H. B. ROBINSON STEAM ELECTRIC PLANT UNIT NO. 2

AMENDMENT TO FACILITY OPERATING LICENSE

Amendment No. 28
License No. DPR-23

ATTACHMENT TO LICENSE AMENDMENT NO. 28

Figure 6.2-1

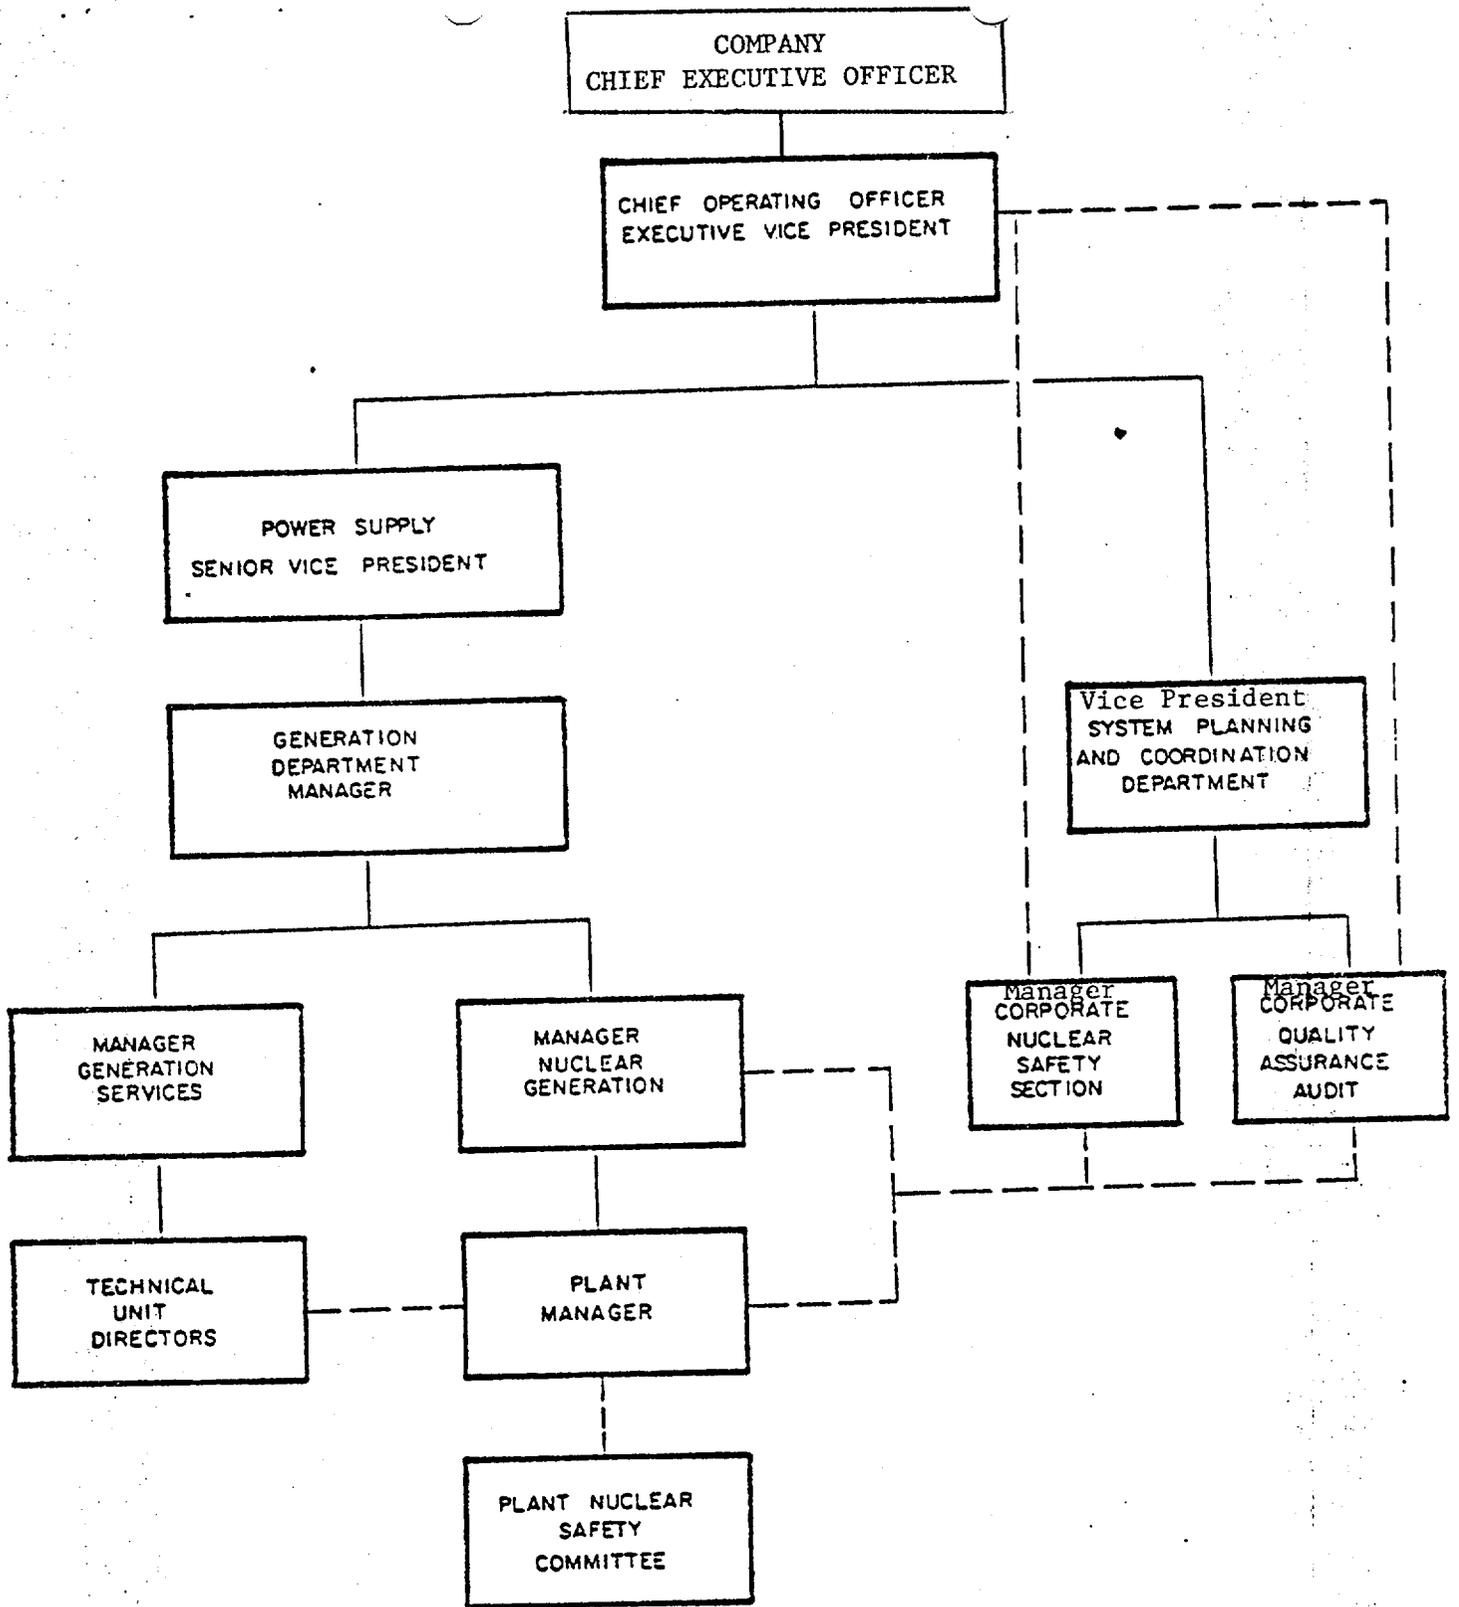
We have reviewed the licensee's new organizational structure as defined by an organization chart included in the licensee's submittal, and have compared it with the organization which was the basis for the present wording of the technical specifications. We have identified the corresponding functional units and managers. We have compared the proposed changes in the wording of the technical specifications and find that the only significant effect is a change in titles. Functional responsibilities and the separation between and independence of operating units and review and audit units is maintained.

In the course of our review, we suggested the addition of position titles to some of the blocks shown on the new organization chart. This was suggested to clarify the relationship between the organization shown in the organization chart and the position titles used in the text of the technical specifications. We also suggested a minor revision in wording to clarify the meaning of "Operations Group," i.e. those organizations reporting to the Chief Operating Officer. The licensee has agreed with both of these modifications.
